RE: *Comments to Docket NHTSA-2020-0067*

Graco Children’s Products Inc. (“Graco” or the “Company”) respectfully submits these comments to the NHTSA’s Docket No. NHTSA-2020-0067 for Federal Motor Vehicle Safety Standard (FMVSS) No. 213 Test Procedure (TP–213–11). Graco has been a manufacturer of child restraint systems since the 1970s and has been a leading innovator in child passenger safety for many years. Graco offers these comments to based on our experience as a manufacturer as well as the company’s extensive test program.

Figure 1. Graco Impactor Frame Assembly and Base Plate.

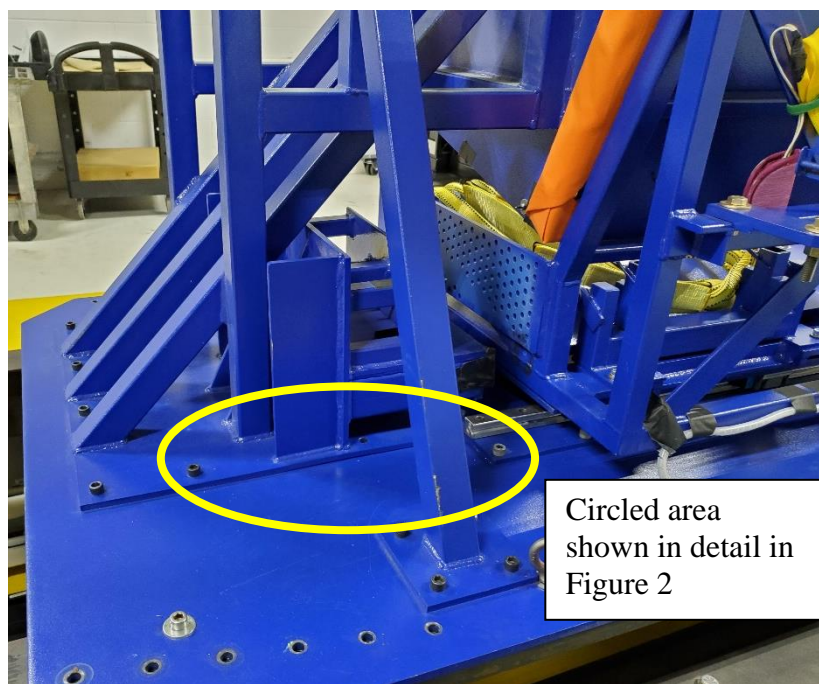
As shown in Figures 1 through 7, the structure of the SISA base plate that supports the Impactor Frame Assembly (door and hexcell support structure) is bending during testing. This phenomenon was identified at five different laboratories. Newell Brands recommends that a base plate flatness check method be added to TP-213, where the gap between the base plate and the sled base is measured directly and should be no greater than 3 mm. These measurements are important to

identify when the SISA is out of tolerance due to the base plate bending, and to trigger a requirement to repair or replace the affected structure.

A frequency for this check step should also be added to TP-213 to ensure that damaged structures do not bias test outcomes. Because the door foam is attached to the door structure, bending of the structure can position the door foam so as to affect the arm rest height, which is a critical factor to the outcome of chest displacement with the Q3s and head contact with the CRABI dummies.

Figure 9. Recommended Camera Location for Pre-Test Photograph.

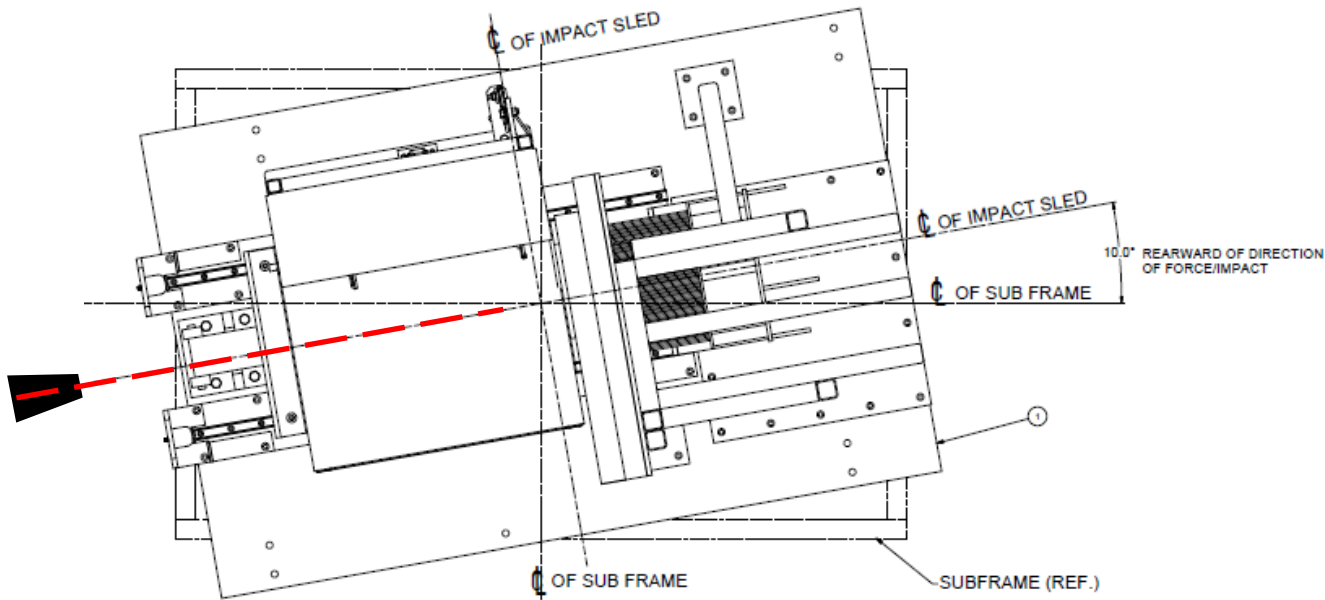
With respect to chest deflection, it can be difficult to detect what causes variation in results. Having consistent setup photos from run to run is helpful in determining possible sources of variation. The view taken as shown in Figure 9 gives a reference for CRS and ATD placement on the SISA bench. Figure 10 shows a pre-test photograph taken with the camera at this location and orientation.

Accordingly, Graco recommends an update to the side impact dynamic test setup procedure at section 12.D.7 in the second group of instructions (following the statement “When all pretest requirements are met”), specifically in step (3), to add a new sub-step ix:

- xii. A photo from a camera mounted on a tripod, perpendicular to the sliding sled and at a height in alignment with the top of the vehicle door arm rest foam, far enough away from the CRS to capture the entire SISA.

Figure 11. HIC Score Variance at Differing Laboratory Relative Humidity Values.

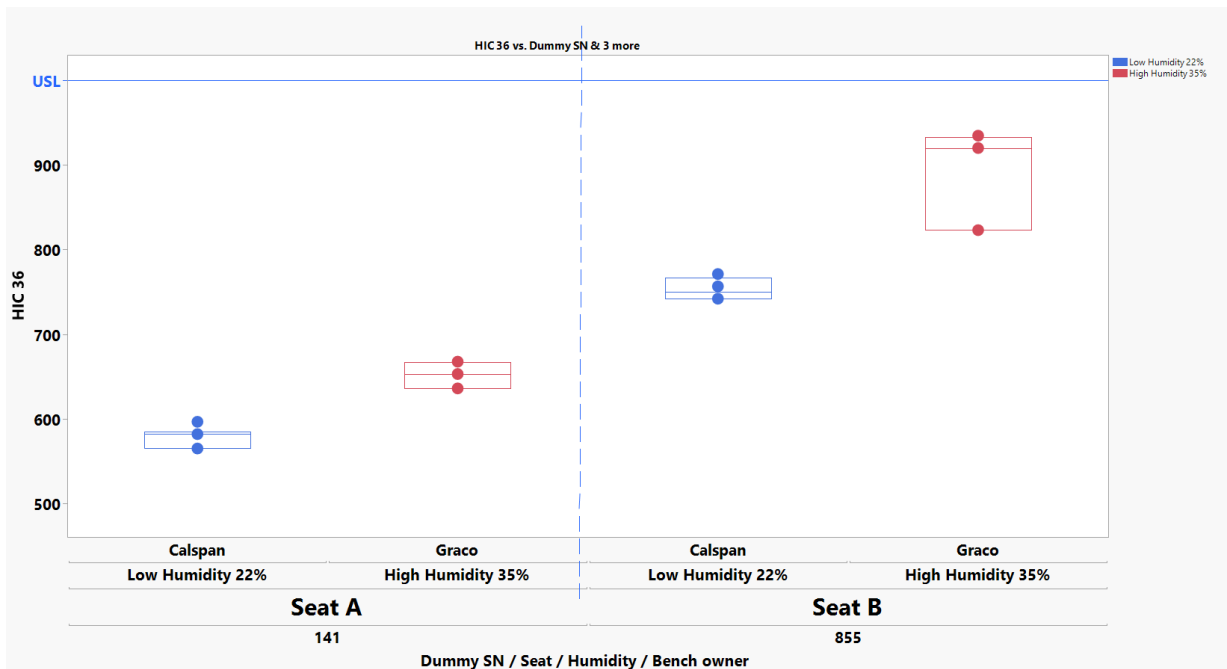
Graco contracted with Calspan to fabricate a frontal impact bench for FMVSS 213b (NHTSA Standard Seat Assembly; FMVSS No. 213, No. NHTSA–213–2021). During a qualification series at Calspan, Graco performed comparison testing using the same child restraint system models, Hybrid III 6-year-old dummies, and sled, with the only variable being the new Graco bench and the existing Calspan bench. In the course of this testing, it was determined that one of the largest driving factors in HIC was the Relative Humidity of the lab. Newell Brands believes that the foam should be stored and tested in a tight temperature and humidity-controlled environment.

Table 2 provides a summary of the experiment design. Figure 11 shows the relative effect of relative humidity in the laboratory on HIC scores at values of 22% RH versus 35% RH. These findings are consistent with prior NHTSA research cited in Section 12.E.1.1 footnotes 4 and 5.

To improve test consistency and to be consistent with side impact testing using the SISA, Graco recommends the following information provided for side impact at Section 12.E.1.1 be added to the frontal test setup at Section 12.D.1.1 A

NHTSA Research has shown that best practices for foam IFD response include storing the foam cushion in a temperature and humidity-controlled environment for at least 24 hours prior to conducting a test. If foam is continuously used, best practice is that under this contract, test labs shall store to foam cushions in an enclosed temperature and humidity-controlled room whenever the cushions are not being used for dynamic testing or undergoing force-deflection calibration. The enclosed room shall meet the following environmental conditions:

Temperature 18.3°C (65°F) to 23.9°C (75°F)

Relative Humidity 50% to 60%
